Notice of Allowability

10/627,028

TURNER, PAUL H.

Examiner's Amendment

FIG. 7

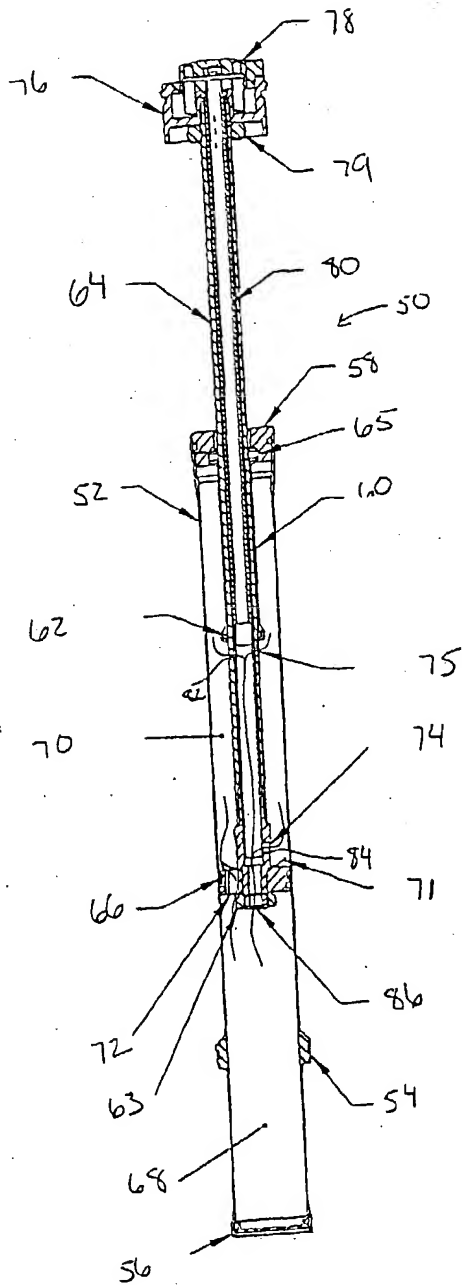
- a. Adds an extension – 59 -- of the sealing member (58) to figure 7.
- b. Page 6 line 26, replaces the word "an" with – in --.

Note: Attachment A shows figure 7 with an added element number 59 as proposed and agreed upon by the attorney. The extension element must also be added to the specification.
